Better engineering standards for cyclists at intersections

This document is prepared in relation to common and recurring issues for cyclists identified at DPTI projects involving widening of arterial roads at signalised intersections.

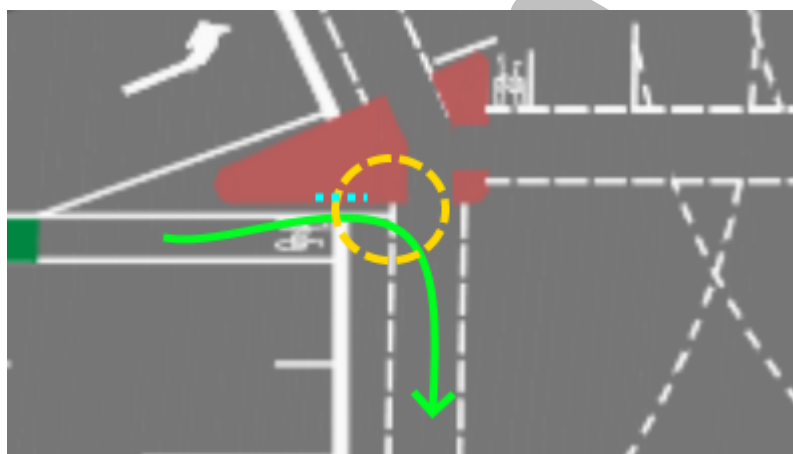
The cross section following illustrates the issues facing a cyclist in a (much) too-narrow bicycle lane with poor tracking in the adjacent travel lane.

The cyclist has very little room to manoeuvre and no escape given an adjacent kerb. The truck's wing mirror is at the edge of the bicycle lane and a hazard to the cyclist, who is working side-to-side out of saddle (perhaps travelling uphill, as yet unaware of the truck coming up from behind). Even if not hit by the truck, any loose straps on the rear of the truck could swing out and hit the cyclist, potentially leading to swerving and/or crashing.

The red arrows illustrate the distance between the lane line and vehicular wheel path. Under central vehicular tracking, the wheels would be some distance from lane lines. This gives rise to an opportunity to enhance cyclist protection by using wider line marking for the bike lane, or by providing dark (i.e. not intended to be visible) audio-tactile line marking on the outside of the bicycle lane. The latter in particular would provide feedback to drivers when they get too close to the bicycle lane.

This type of enhanced treatment is particularly indicated for grades of 5% or above. Here, the alternative of widening bicycle lanes to above 2.0m may encourage cars to enter the bicycle lane.

Example 1: An alternative design to a stand-up lane: the only access is via the footpath/signals.

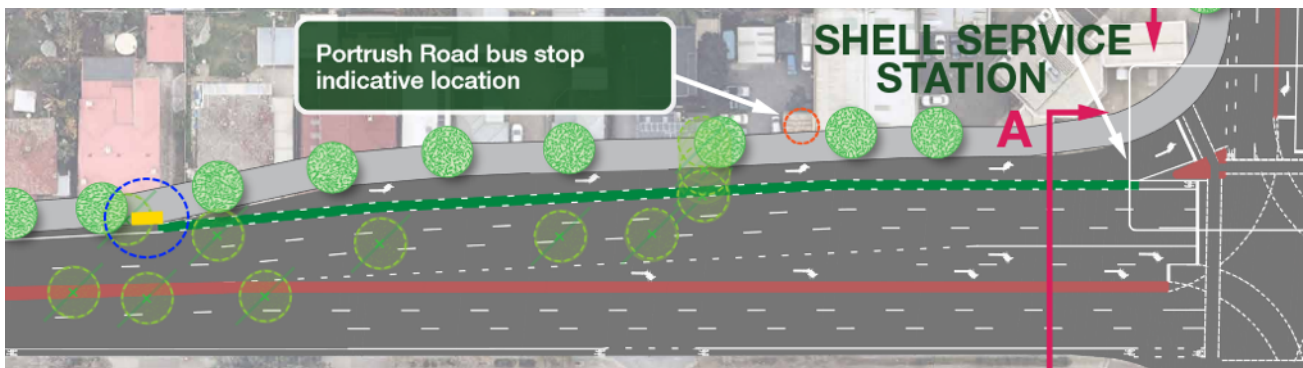
This would typically be in constrained conditions. While road cyclists aren't fond of this design approach when travelling through the intersection, it does enable them to bypass signals entirely when turning left. It can also facilitate safe access through signalised intersections, especially when these are complicated. Adjacent footpath width needs to be adequate for pedestrians and, as cyclists use footpaths in this design, it's not suitable for high-pedestrian areas.

Compared to the example shown, the design should:

- have adequate turning radii between intersecting paths rather than the 90° turns from footpath to splitter island via kerb ramps shown. Austroads specifies a minimum turning radius of 2m.
- have wider footpath crossings, where width exists, to provide a) capacity for both pedestrians and cyclists to wait for signals b) cyclists to pass pedestrians without squeezing these. (The green route shown through the signals provides no room for pedestrians.)

(In **Example 1**, high angle bicycle ramps (45° to the roadway) may be acceptable to slow cyclists to an appropriate shared path speed, although other design indications do not appear to cater for pedestrians. Again, AGRD Part 3 illustrates design details for such an application.)

Example 2: Stand-up lane alternative design where land acquisition gives additional space.

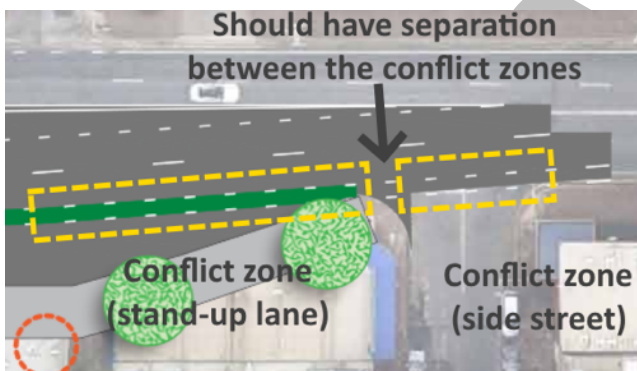
The long stand-up lane provides access for high-speed (“strong and fearless”) road cyclists who are comfortable riding in traffic. For others, providing a convenient kerb ramp in the area shown in yellow (and circled in blue) would enable a footpath-level bike path to be provided, separate to both the footpath and roadway. (The design of cyclist kerb ramps is discussed in the next section.) As the resulting bike path would be adjacent to the kerb, a small additional buffer should be provided between the kerb face and bike path. (This can be as simple as a white line delineating the space or be part of an attractive streetscape design.)

Example 4: Magill Road/Portrush Road intersection project.

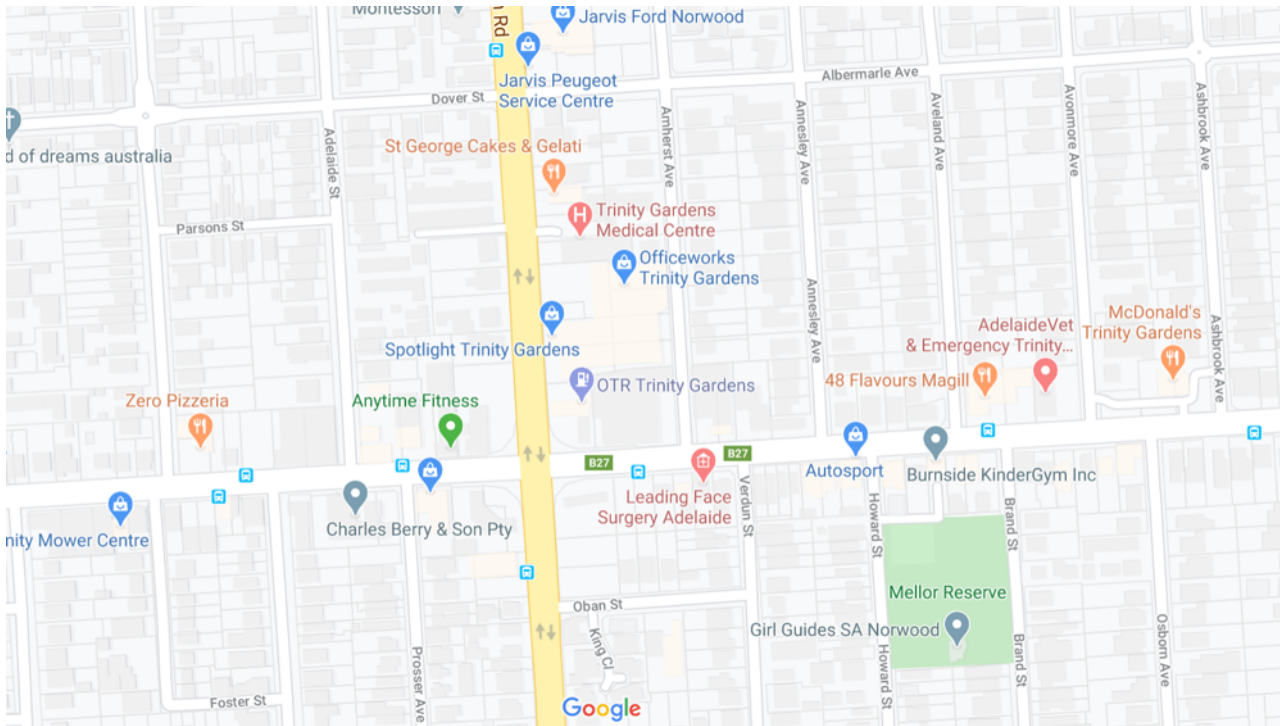
Retail on the north-east corner of the intersection (St George's Cakes and Gelati, Trinity Gardens medical centre, Officeworks and Spotlight) are all likely to produce relatively local travel. There are no nearby pedestrian crossings of Magill Rd, which also doesn't have a median that would help make crossing it easier. Therefore, in terms of accessing these local shops:

The most significant implication of the intersection redesign is that crossing Portrush Road at Dover Street/ Abermarle Street will be markedly less safe and convenient for cyclists. To cater for existing cyclists who use the north-eastern footpath, and to provide a safe alternative for cyclists who currently cross Portrush Road at Dover Street:

- cycle paths should be provided on footpaths along Magill Road from Prosser Avenue and Adelaide Street to the lights
- a cyclist median crossing of Portrush Road should be provided at Clifton Street (the next street north of Dover St) as an alternative for some people
- the north-eastern footpath of Portrush Road should be widened between Abermarle Street and Magill Road
- the pedestrian splitter islands should be increased in size.

In comparison, the original project scope excludes Portrush Road's north-eastern and south-eastern footpath as road widening involves land acquisition only to the west of the original road alignment and changes to pedestrian/ cyclist use of existing footpaths are not considered.
